Drawing List:

Tice River Homes Legacy

A0

GROUND FLOOR ELEV. 'A'

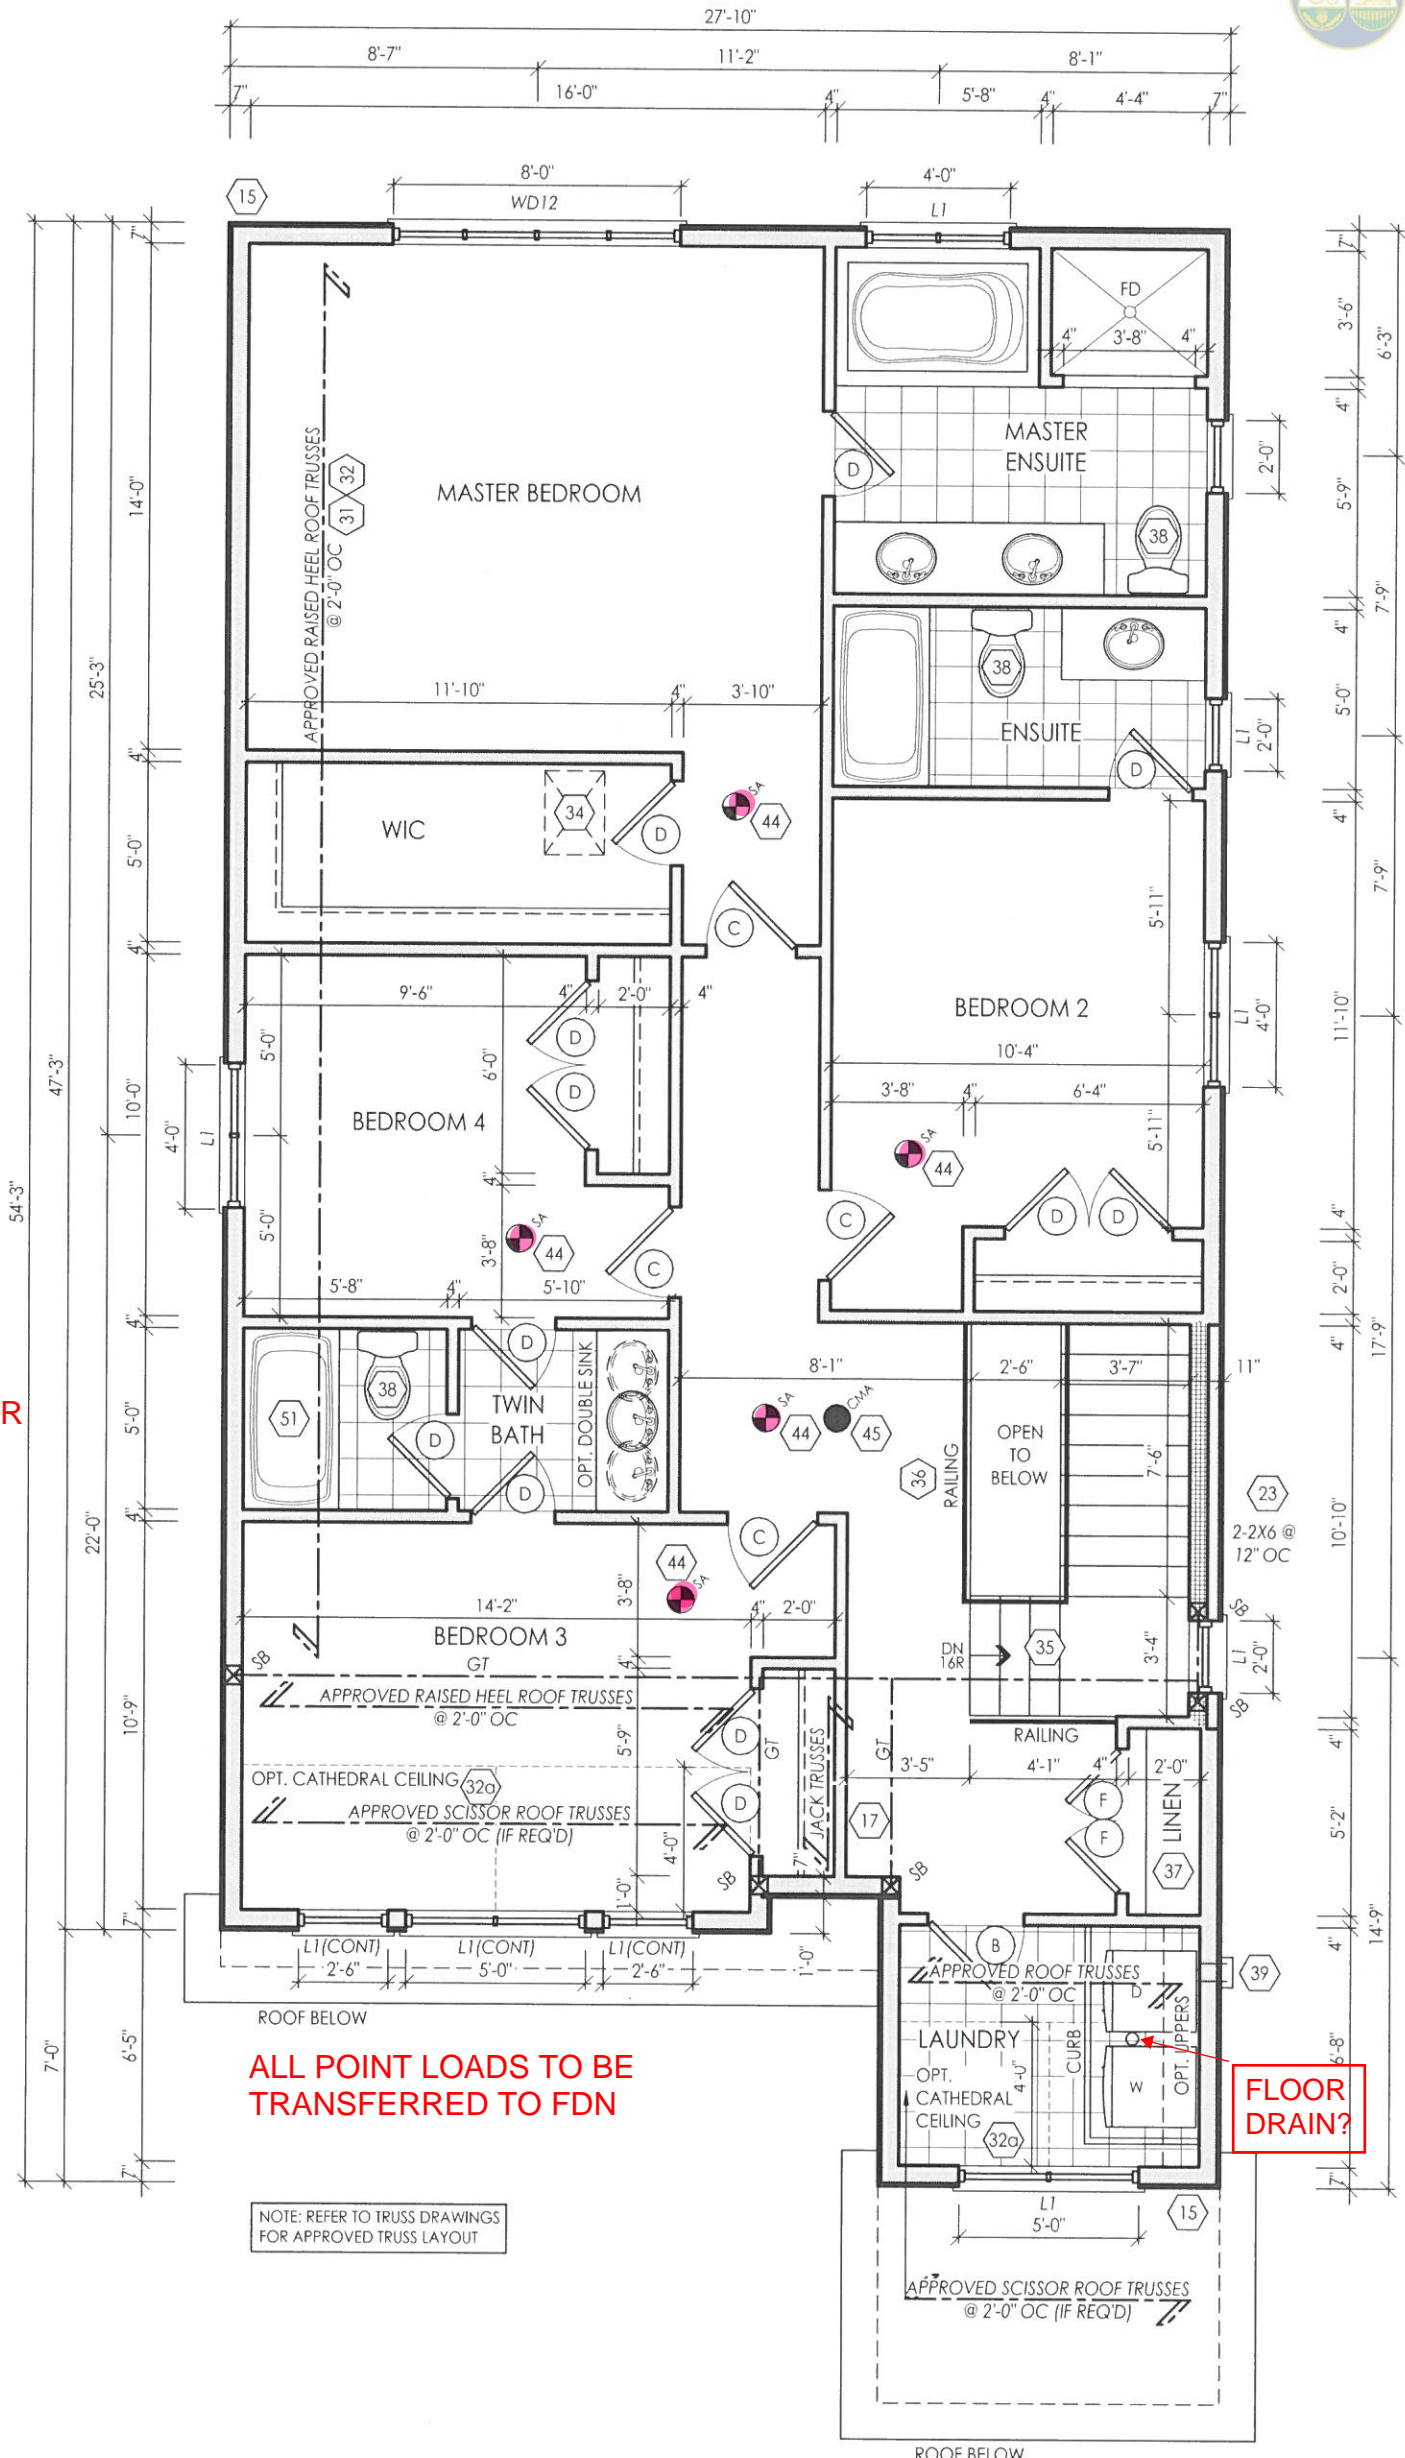
LINTEL PACKAGE AND ENGINEERED BEAM
DETAILS TO BE SUBMITTED PRIOR TO
FRAMING INSPECTION

MAX PROJECTION
INTO REQD SIDE
YARD 0.3M

KITCHEN, BATH &
LAUNDRY FLOOR
AS PER 9.30.1.2

BEAM/FLOOR
CONNECTION
DETAILS REQD AT
FRAMING

GARAGE
MANDOOR TO
BE SELF
CLOSING AND
WEATHER
STRIPPED

52 IS MISSING
FROM NOTES

SECOND FLOOR ELEV. 'A'

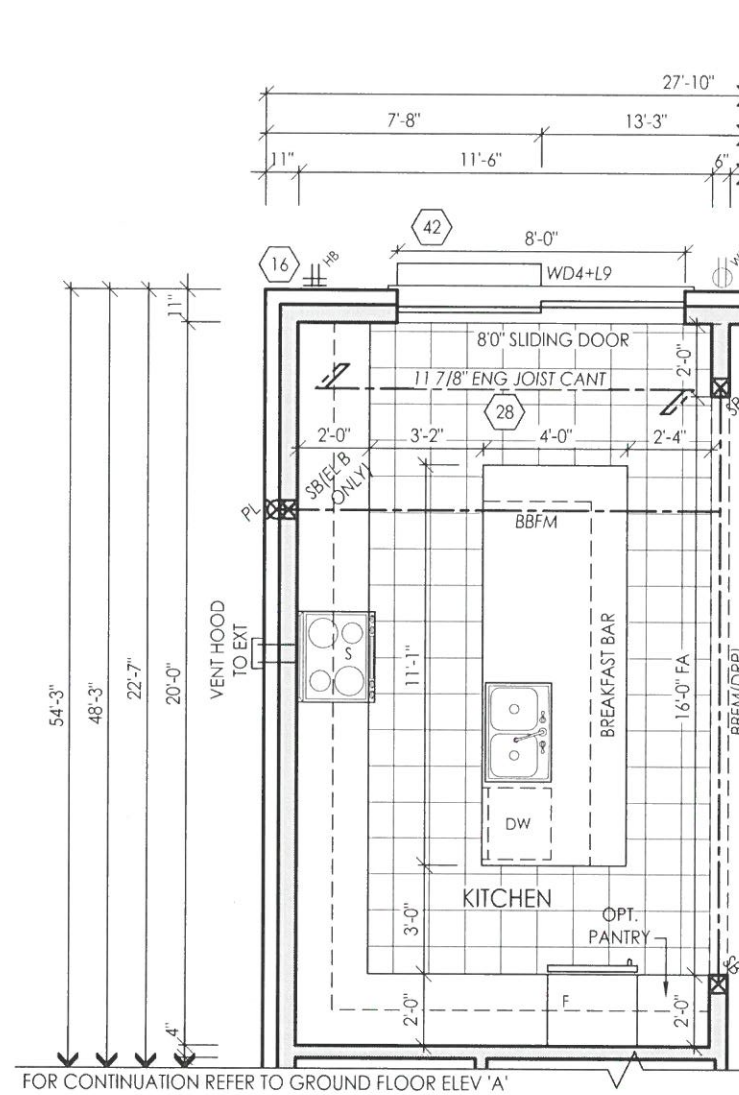
ENGINEERED FLOOR LAYOUT, TRUSSES AND LINTELS TO BE SUBMITTED PRIOR TO FRAMING. DESIGNER TO COMPLETE RESPONSIBILITY REVIEW FORM AND TO BE SUBMITTED WITH TRUSS, FLOOR AND LINTEL DOCUMENTS.

MAIN BATH TO HAVE GRAB BAR BLOCKING

WINDOW ON LANDING MUST BE HIGHER THAN 3' ABOVE OR ENGINEERING ON WINDOW OR GUARD REQD

ALL POINT LOADS TO BE TRANSFERRED TO FDN

FLOOR DRAIN?
